December 22, 2015

Public Works and Government Services Canada
201-1800 11th Avenue, Broad Street Crossing
Regina, Saskatchewan

Re: Food Services Building – Investigation of Saturated Crawlspace

RAWLSPACE INVESTIGATION - EXTERIOR WEEPING TILE

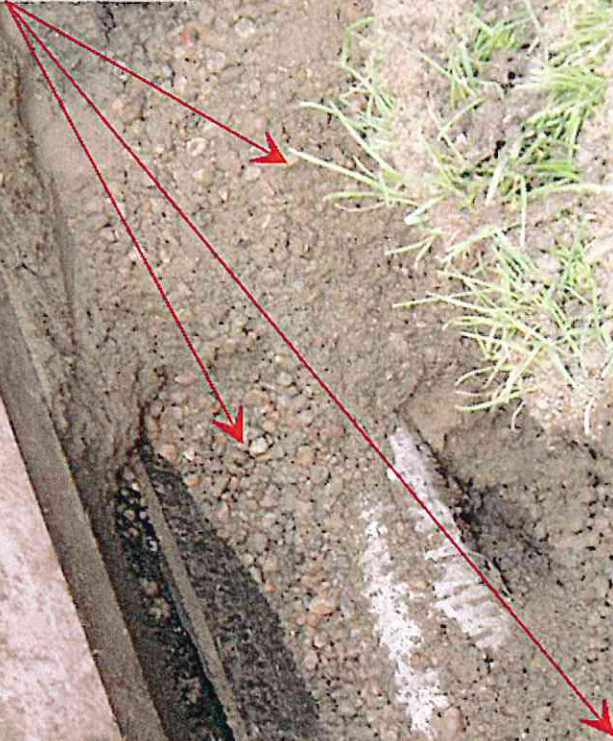
MIXTURE CONTAINS
TOO MUCH SMALL
SEDIMENT. LARGE
CRUSHED GRAVEL IS
REQUIRED AS PER
ORIGINAL DRAWINGS.

SUMP PIT CONNECTIONS

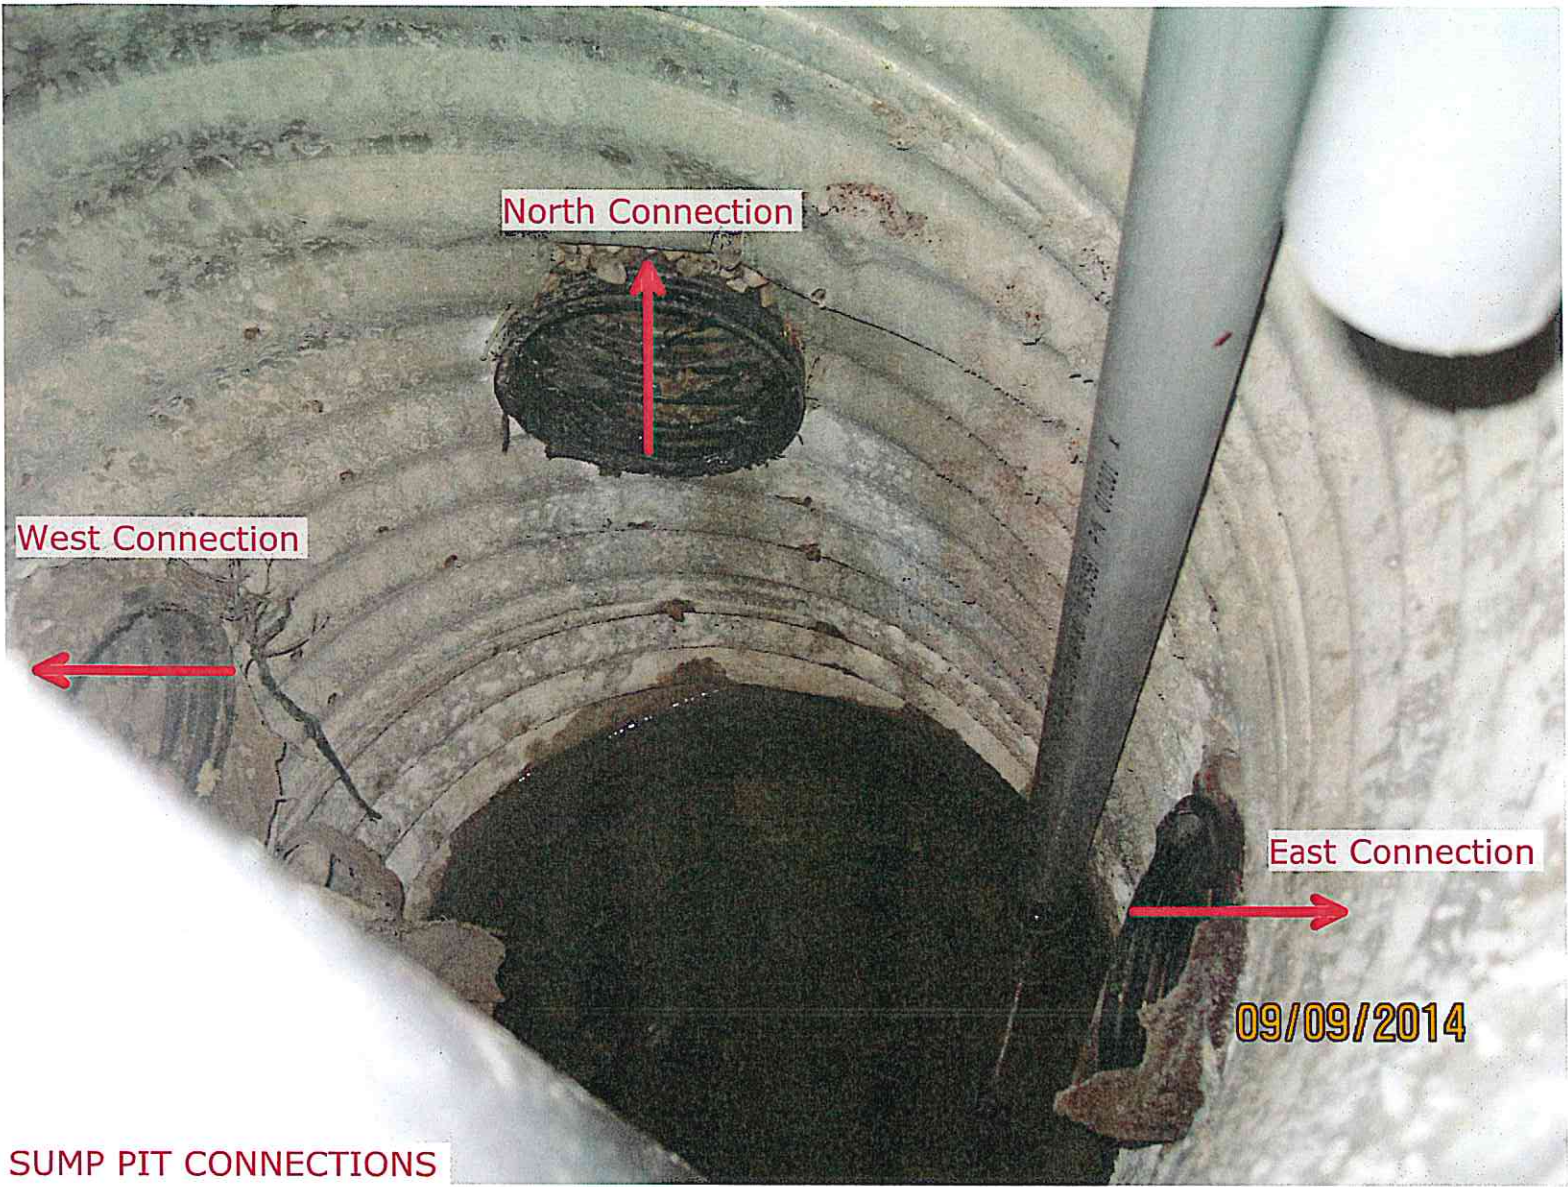
Material pushed through gaps surrounding pit wall and connections.

Wash out inside North and East connections. Possible break in weeping tile line upstream.

NORTH AND EAST CONNECTION AT SUMP PIT

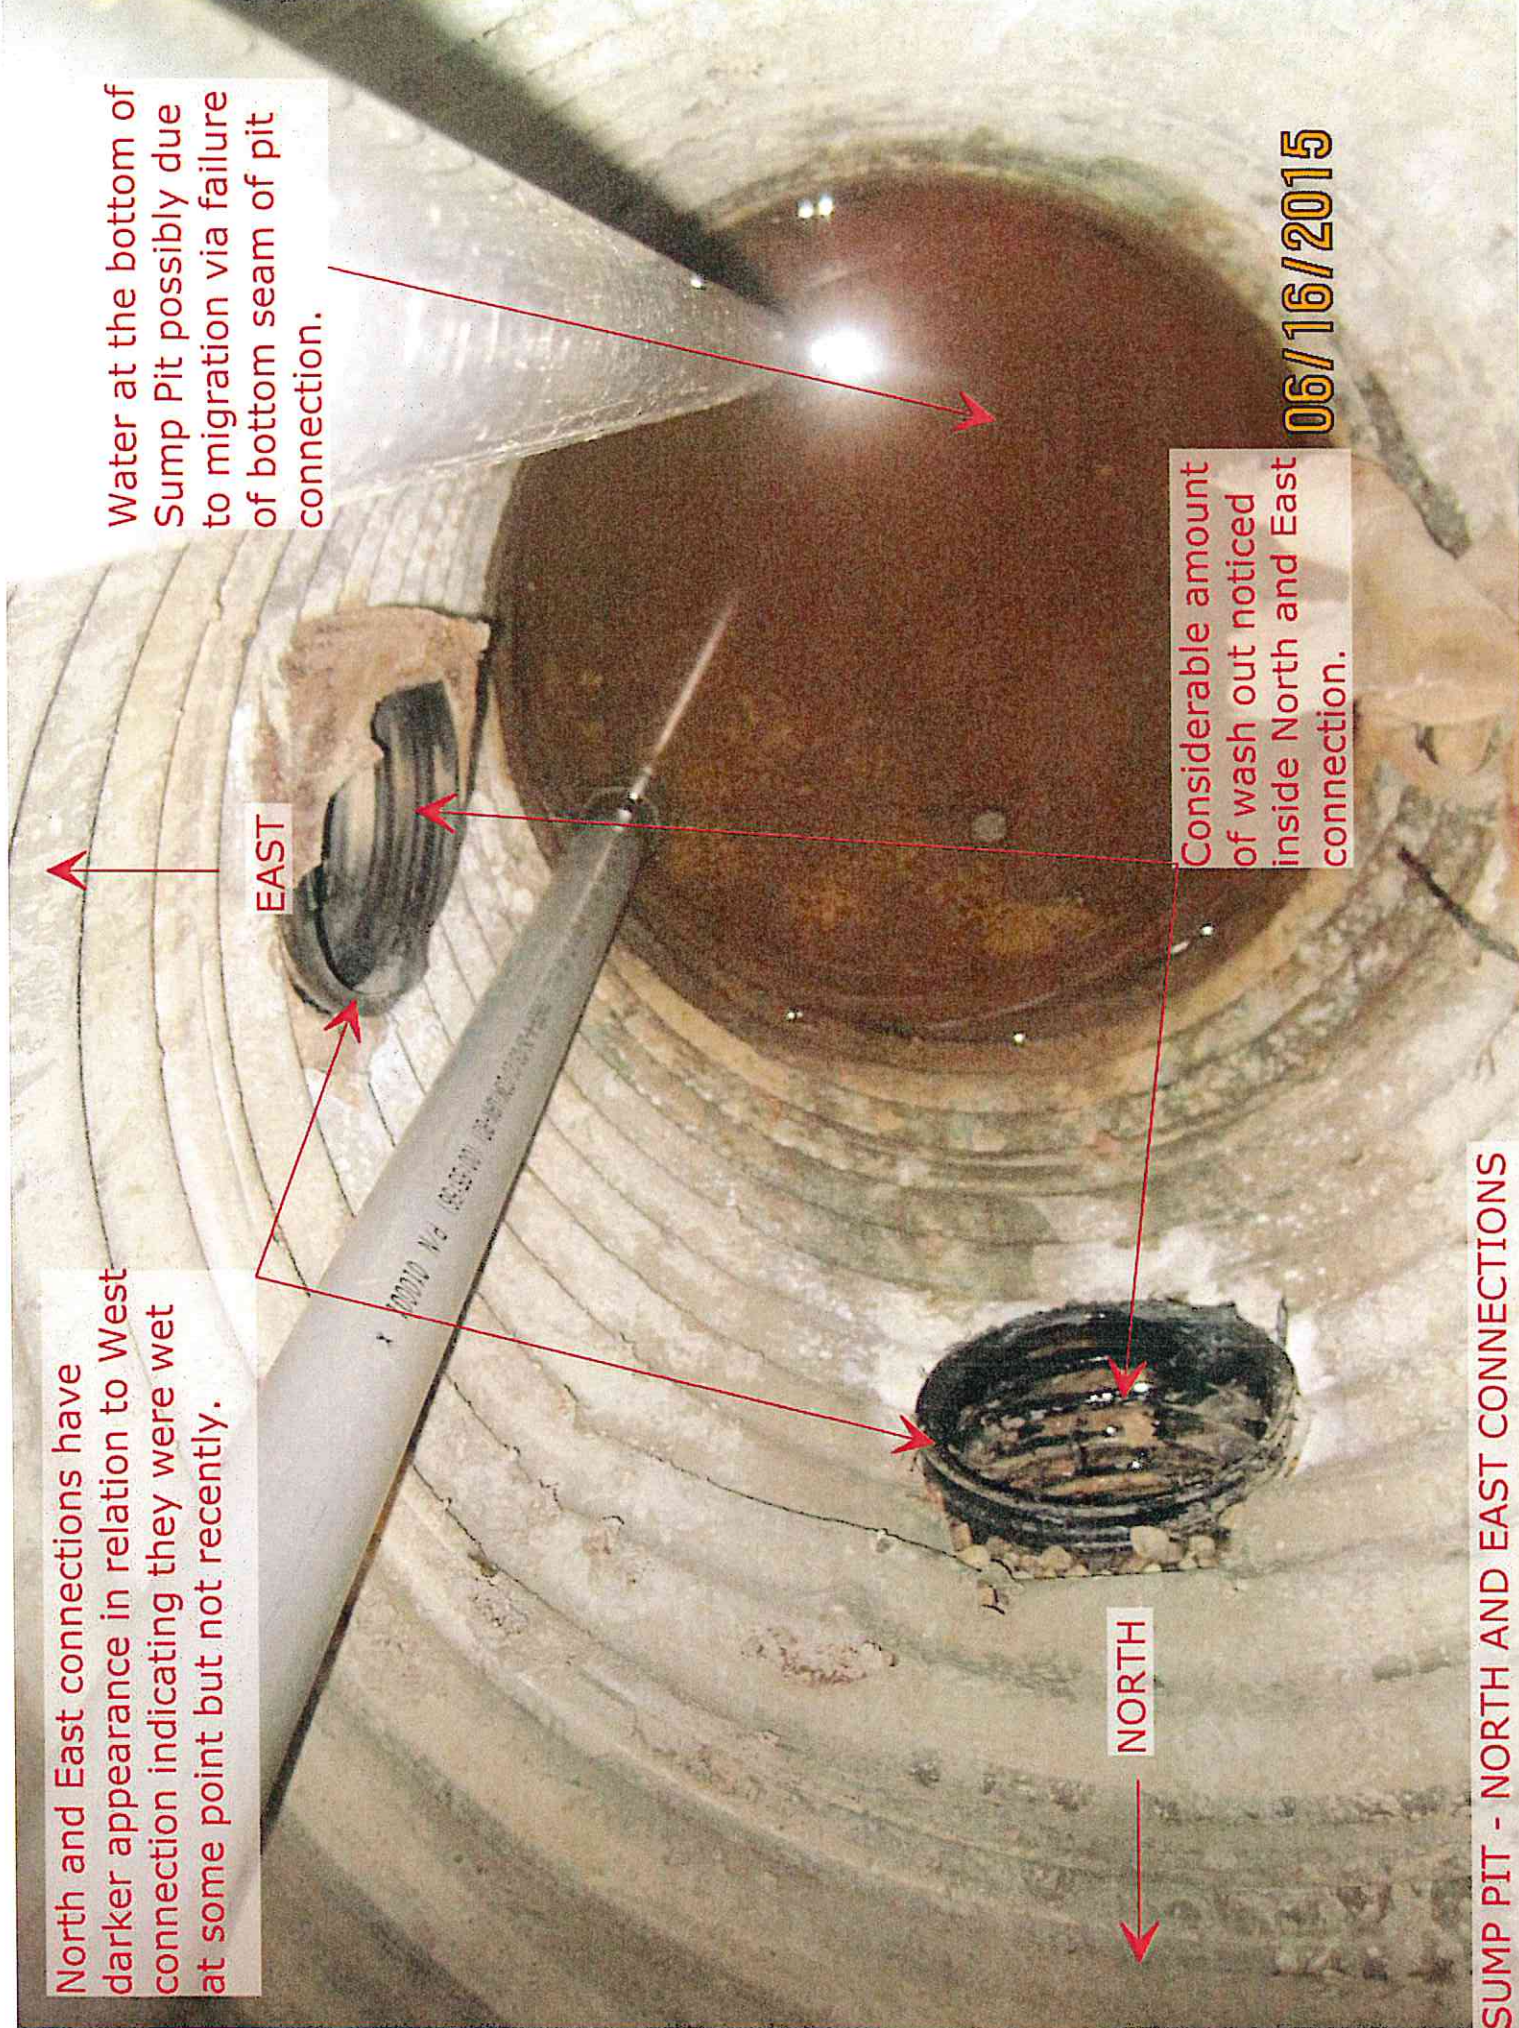
North and East connections have darker appearance in relation to West connection indicating they were wet at some point but not recently.

Water at the bottom of Sump Pit possibly due to migration via failure of bottom seam of pit connection.

SUMP PIT - NORTH AND EAST CONNECTIONS

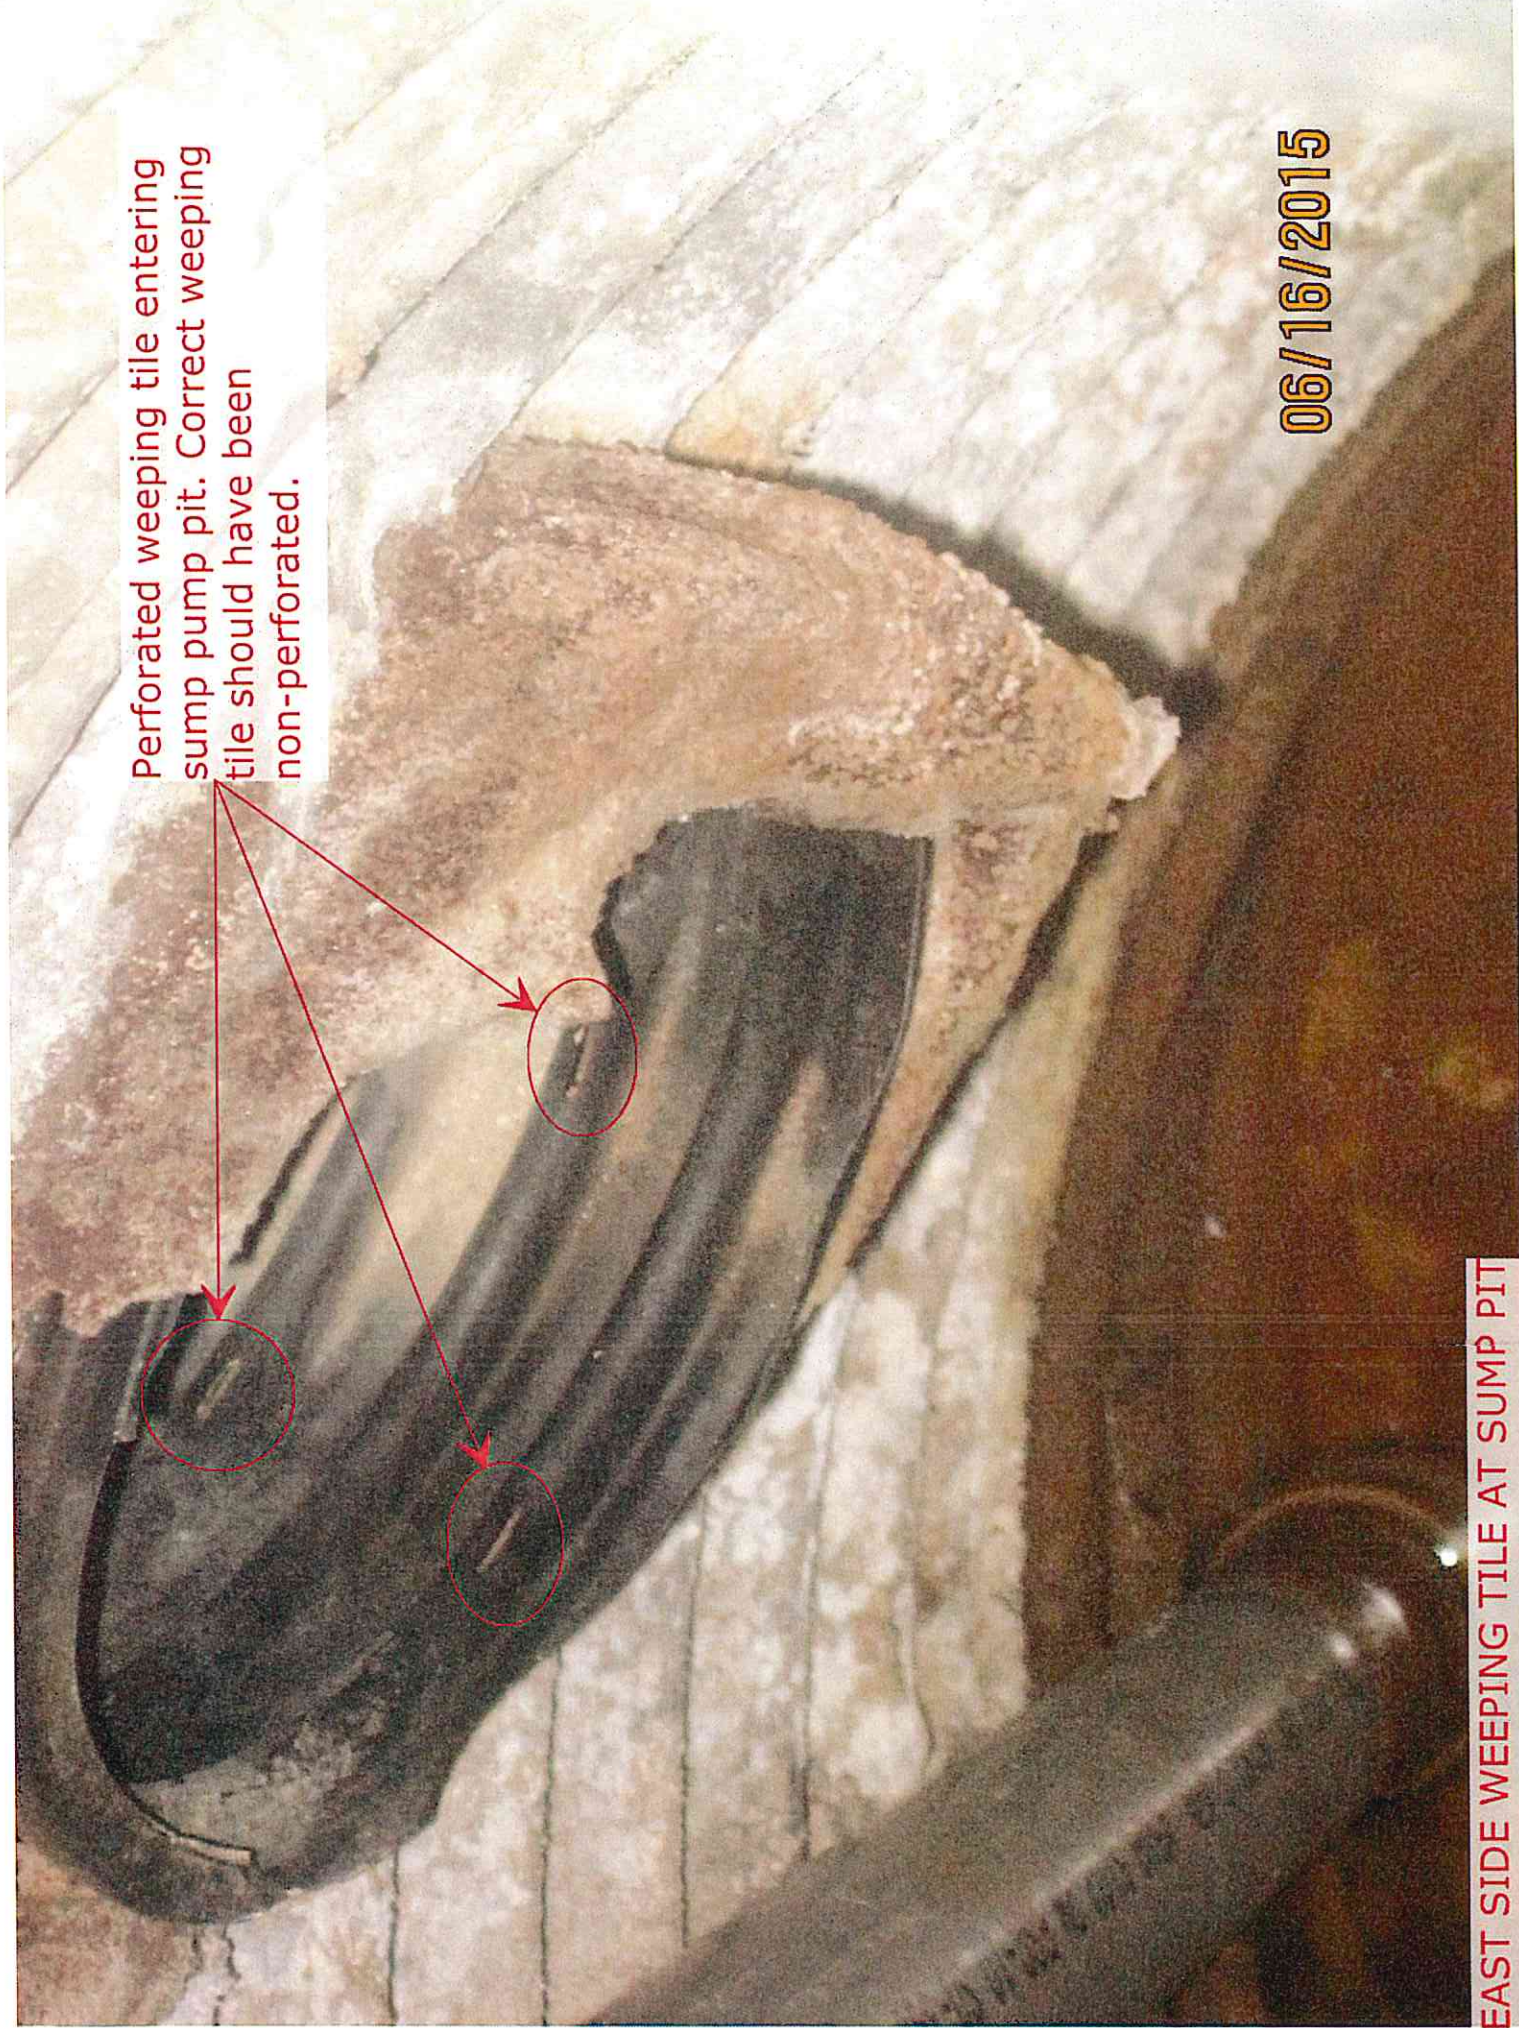
Considerable amount of wash out noticed inside North and East connection.

Perforated weeping tile entering sump pump pit. Correct weeping tile should have been non-perforated.
